Land at Gosford

Technical Note 11: Response to Oxfordshire County Council (OCC)

22nd June 2023

Appendix C – Vehicle Tracking

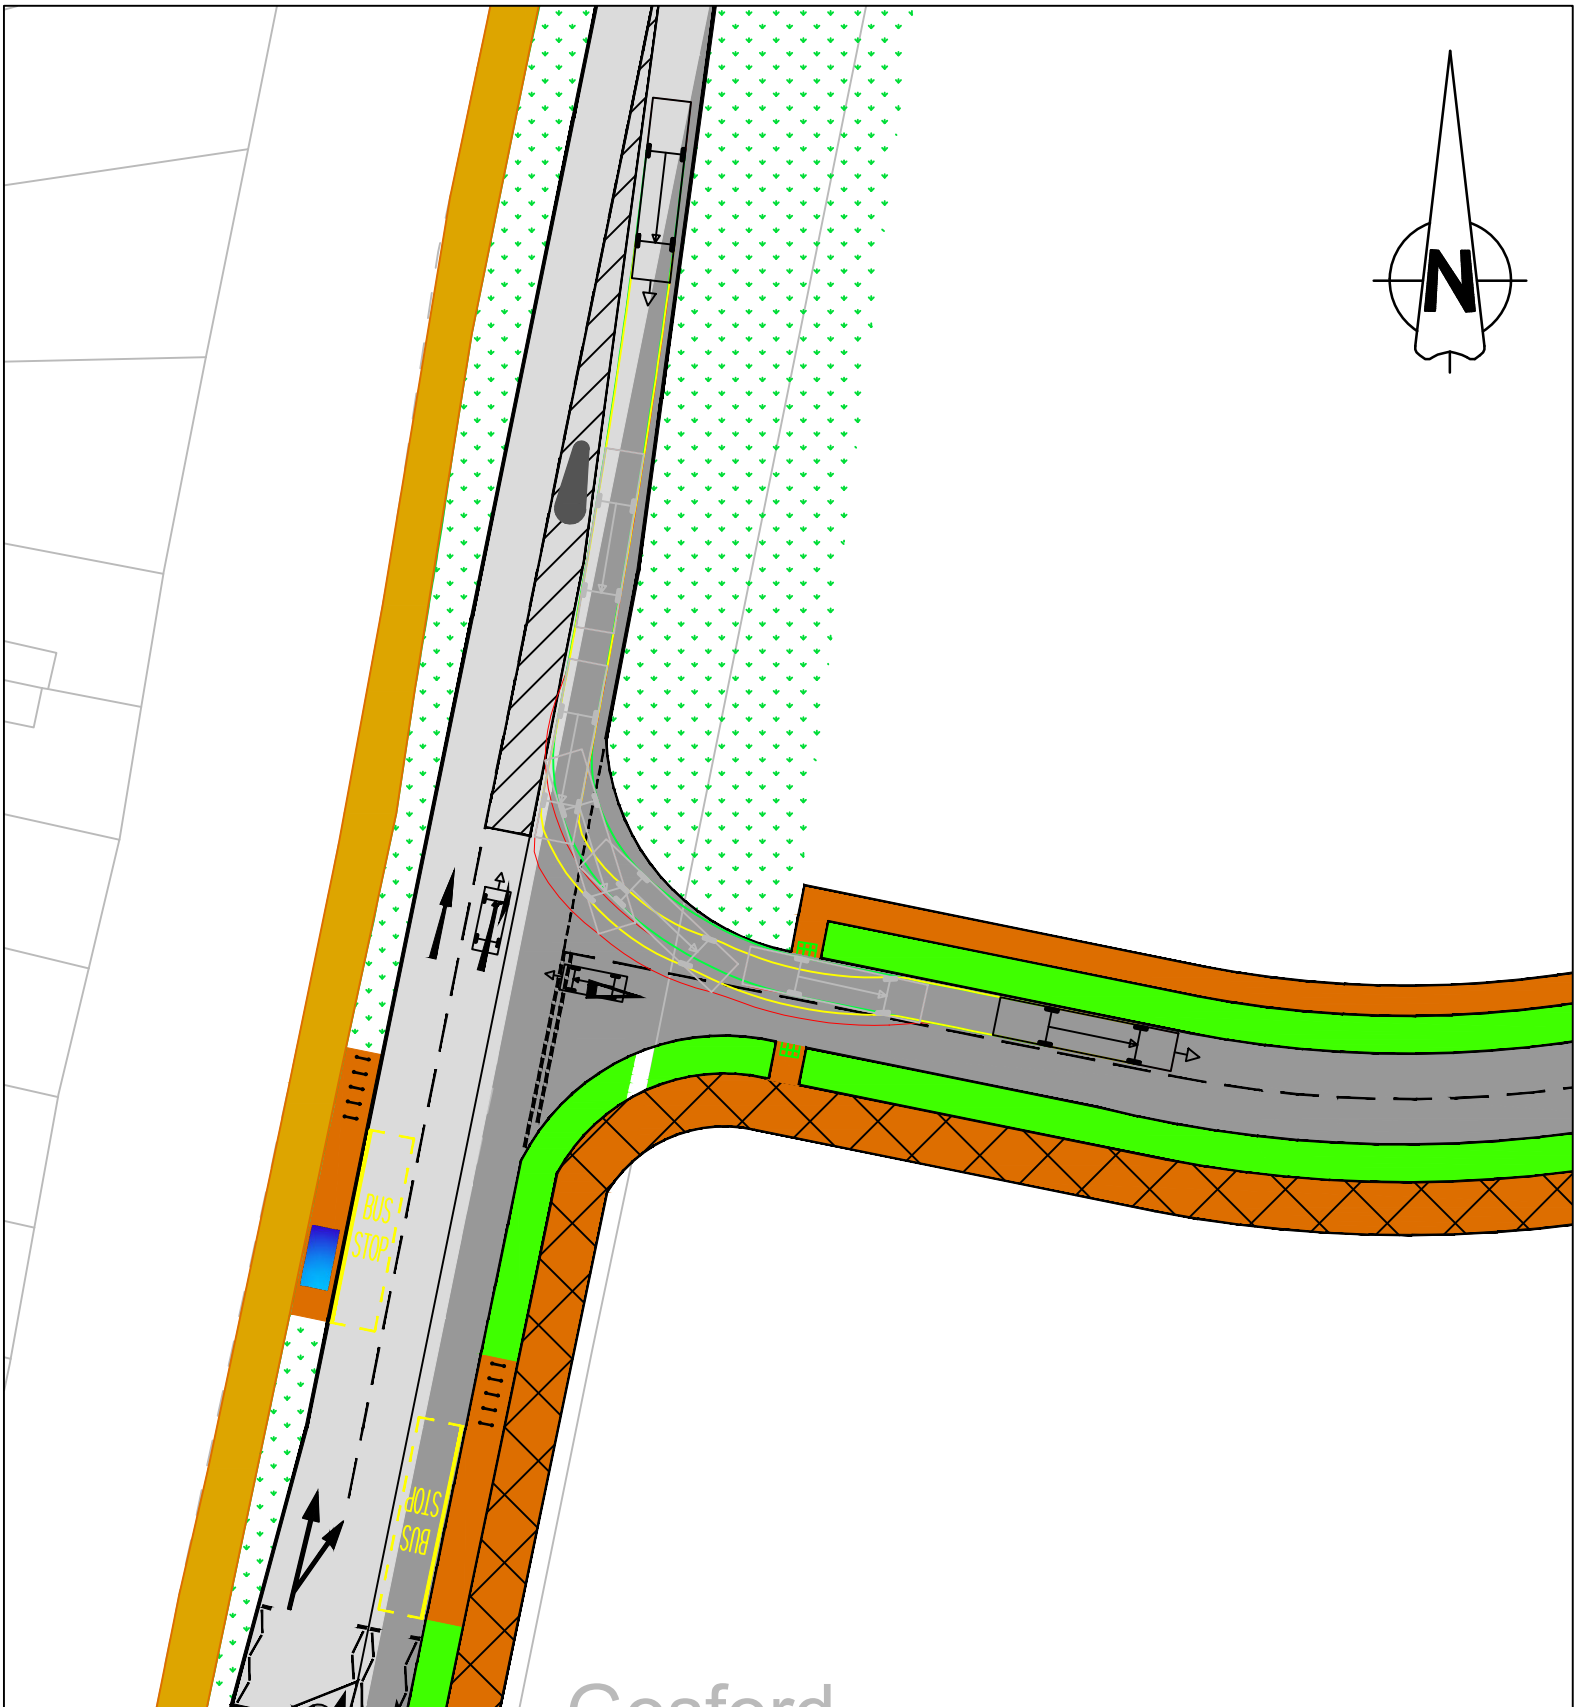
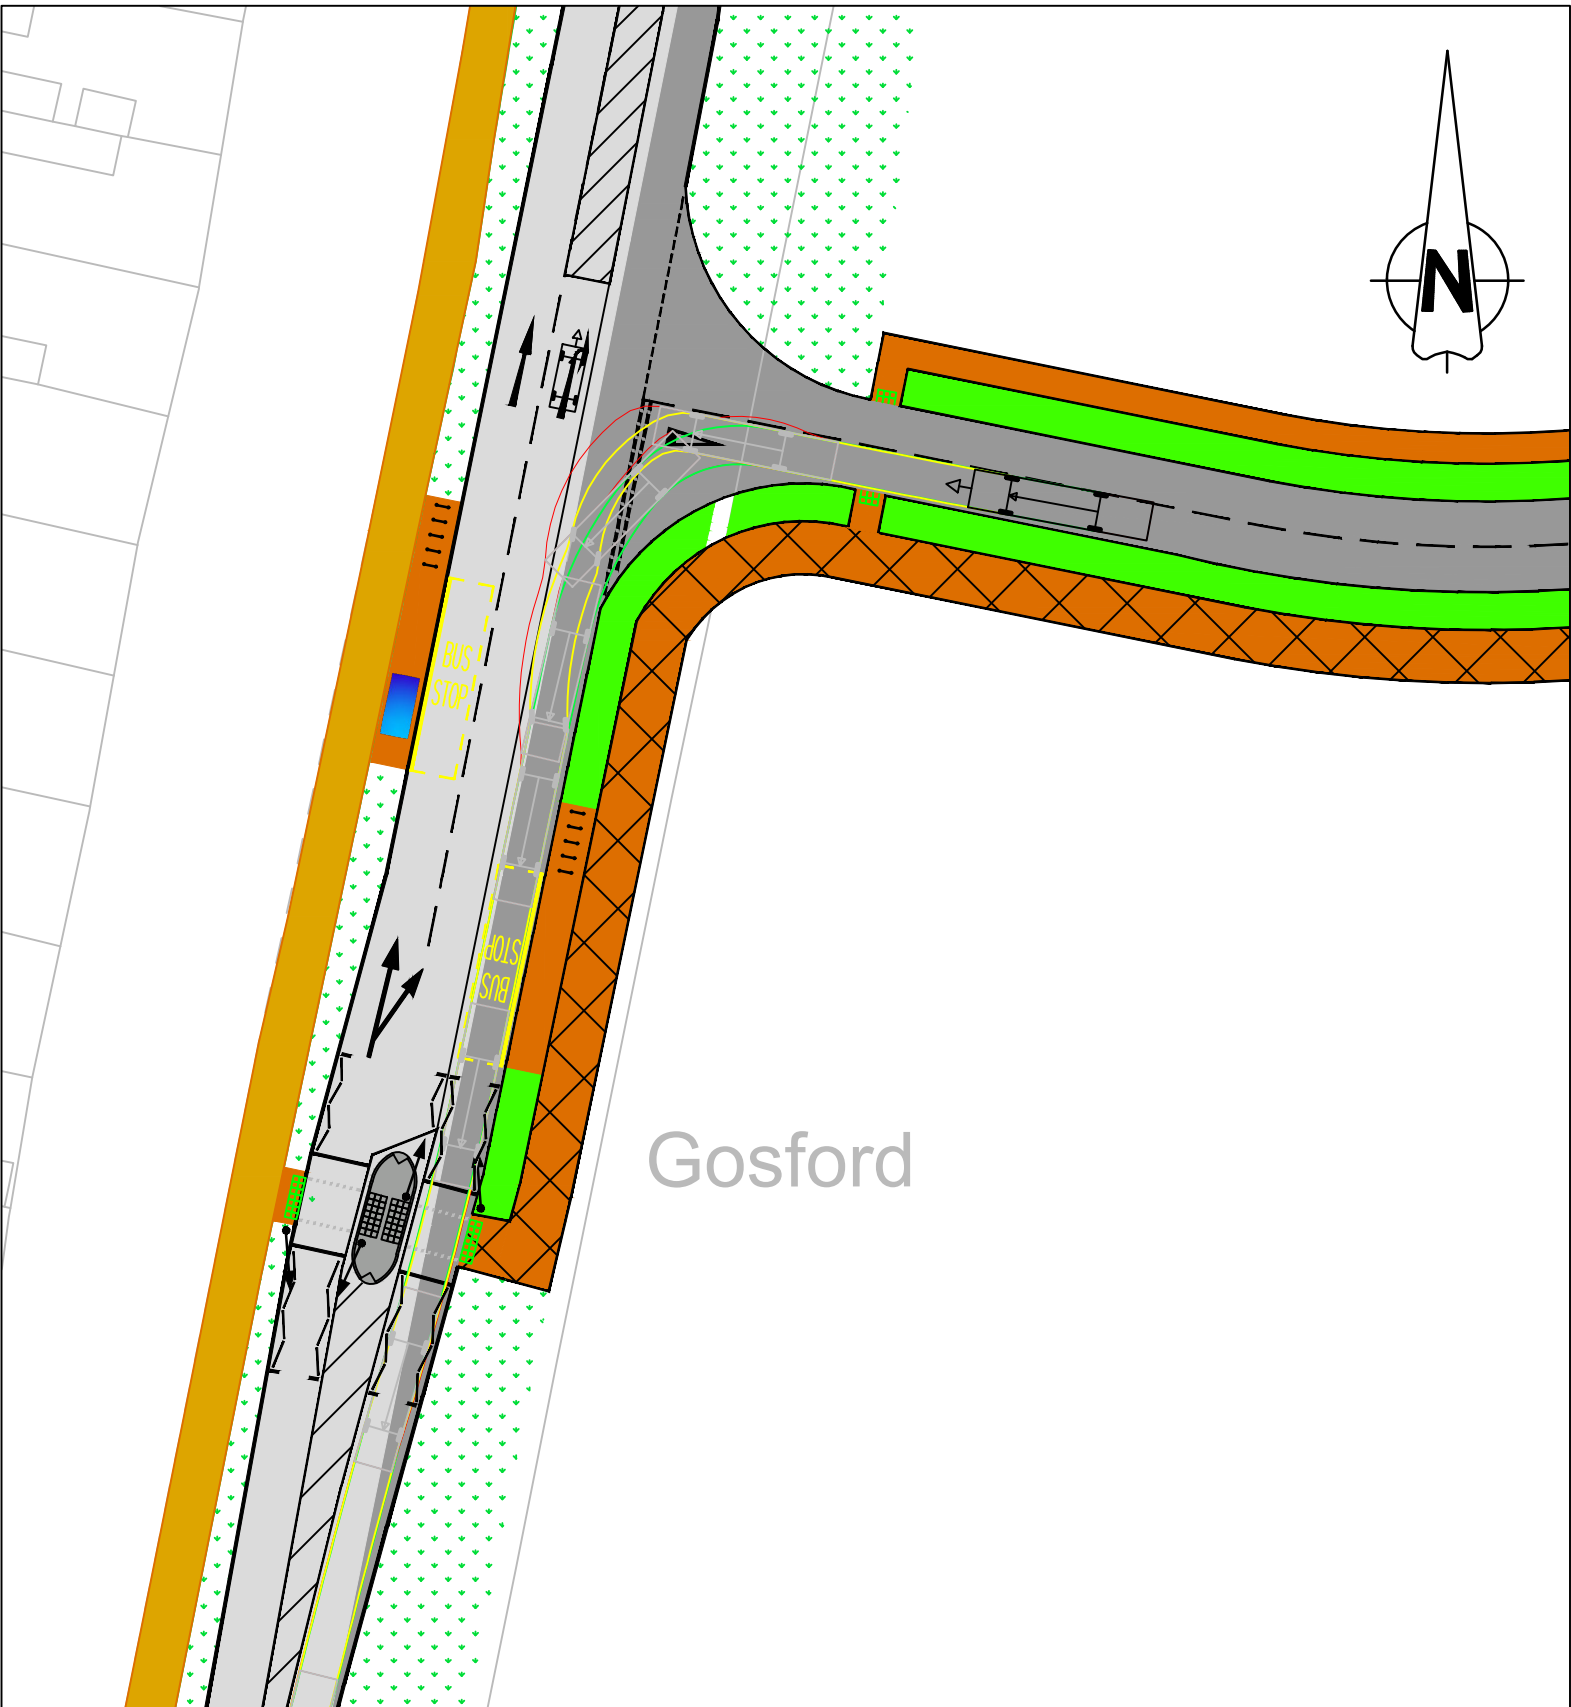
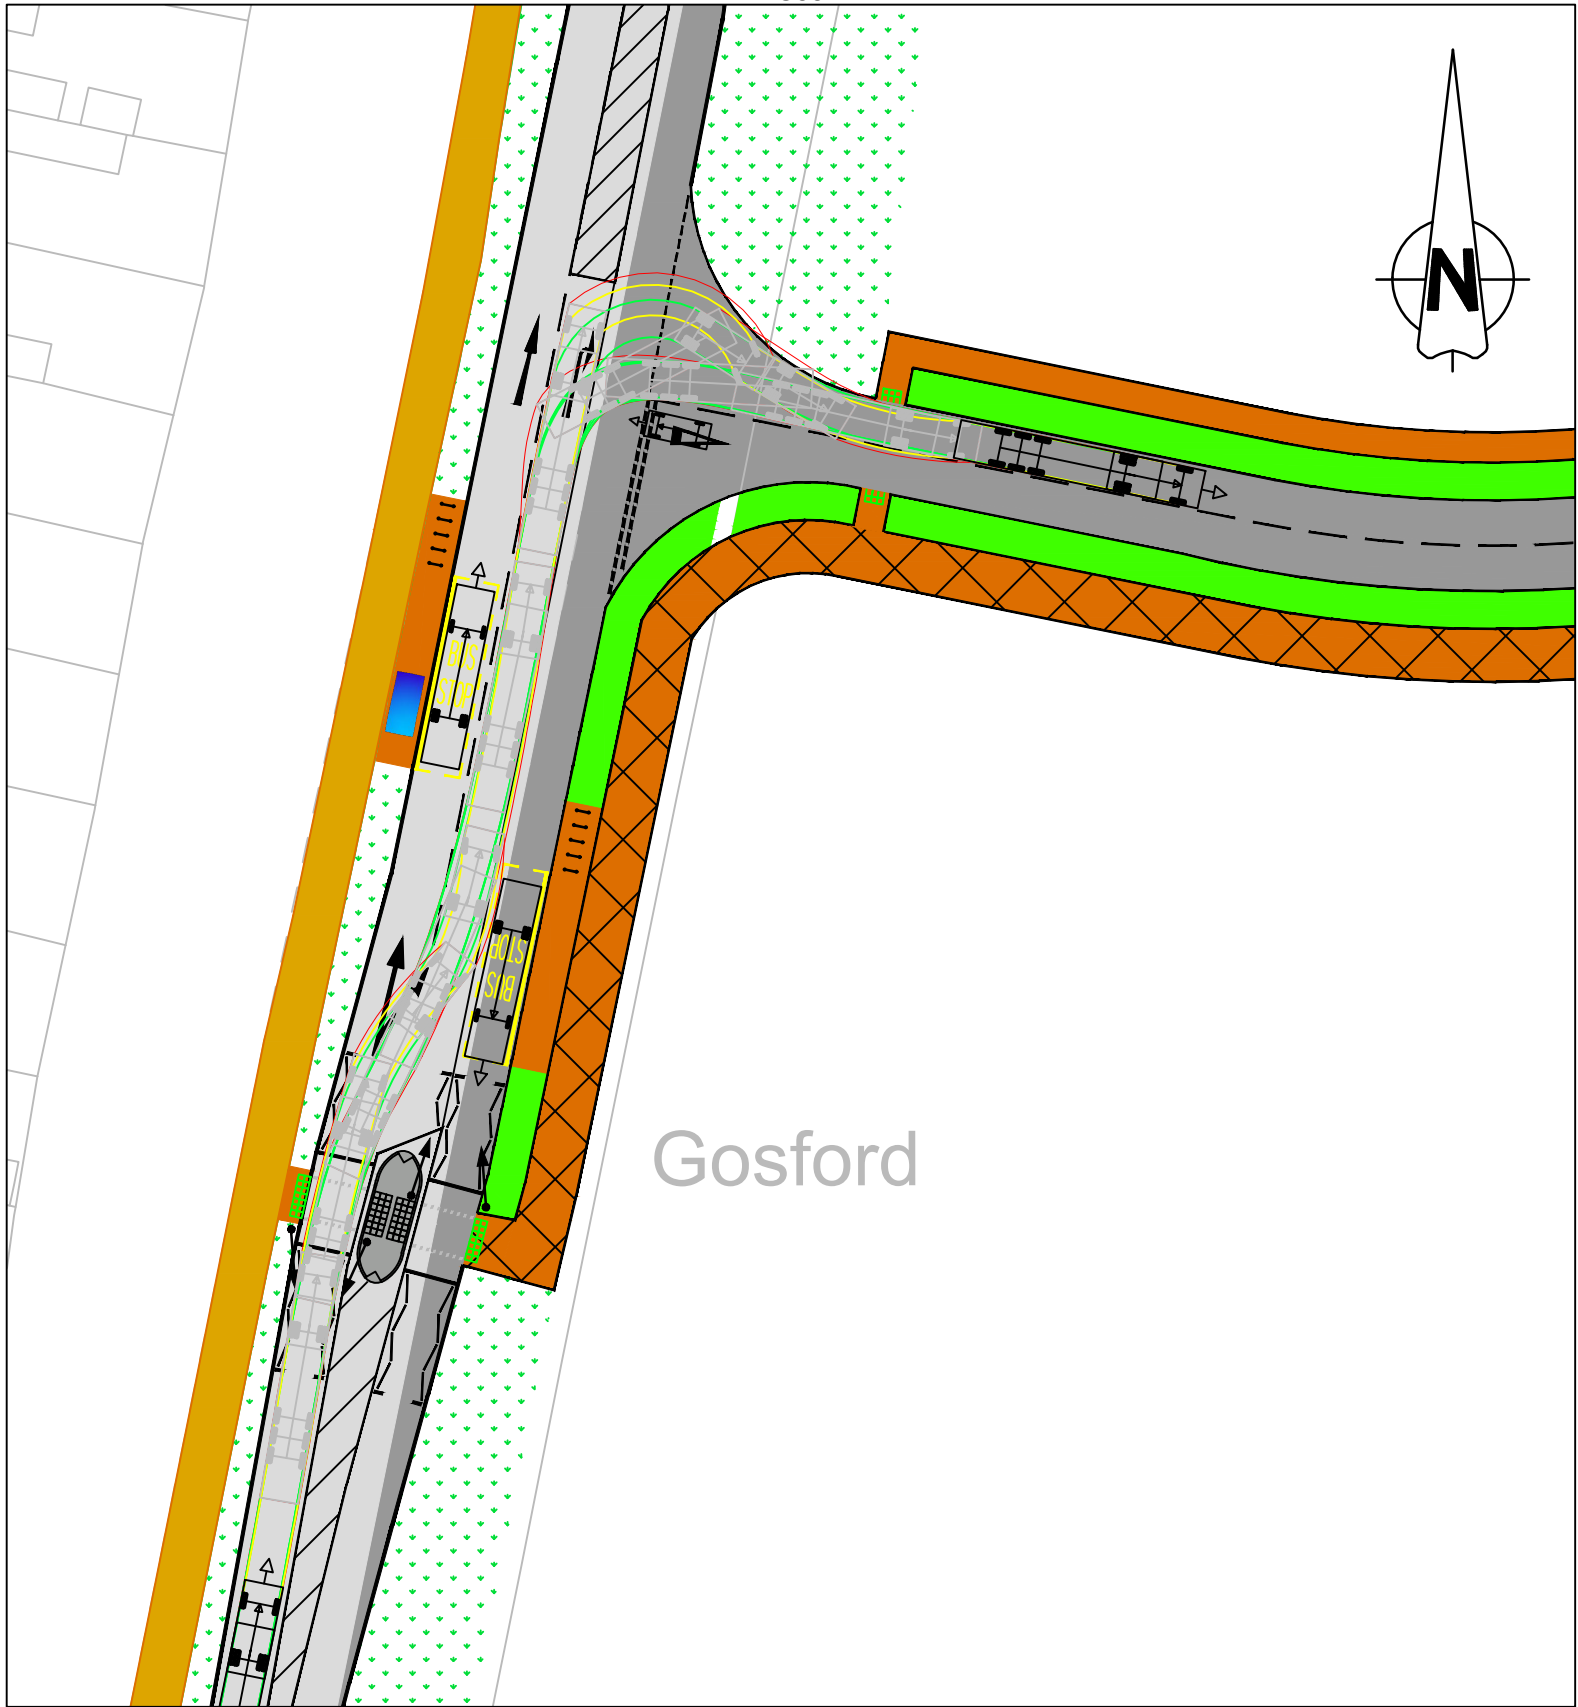
OCC Comment: Para 4.4 mentions a swept path exercise that has been undertaken at the access points to ensure/ demonstrate that the development can be safely served by large vehicles. It goes on to state that the swept path details are provided in Appendix D. Interrogation of the TA and indeed other documents fails to reveal the swept path drawings at any of the site accesses. The swept path drawings must be submitted to show that the site accesses can safely accommodate expected vehicles.

- 3.5** This is noted and the drawings are contained in **Appendix C**.
